L1_Cal test stand ORC review responses.

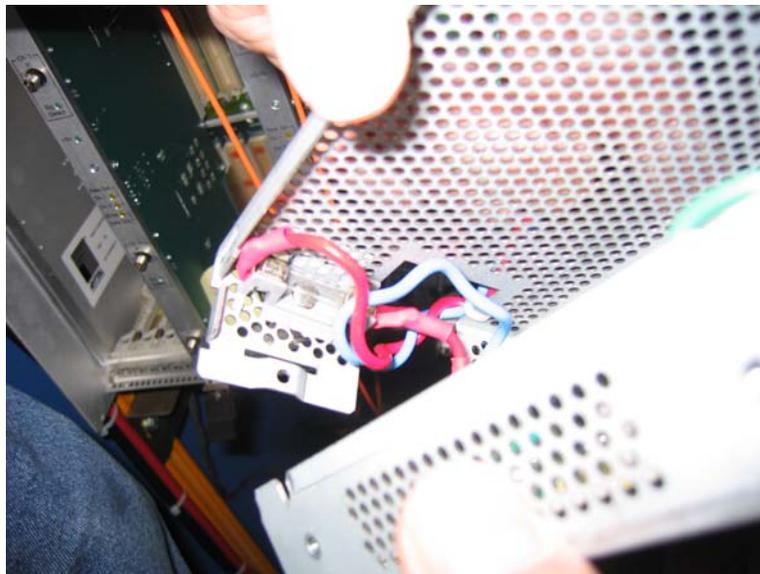
3. Verify that TAB/GAB backplane connection hardware stack uses a copper or brass flat washer between the power cable and backplane.

Response: The hardware stack was inspected for washer material compliance and was found to be stainless steel. All four connections have been made in the following order: Bolt - backplane – brass flat washer – lug – flat brass washer – lock washer – nut.
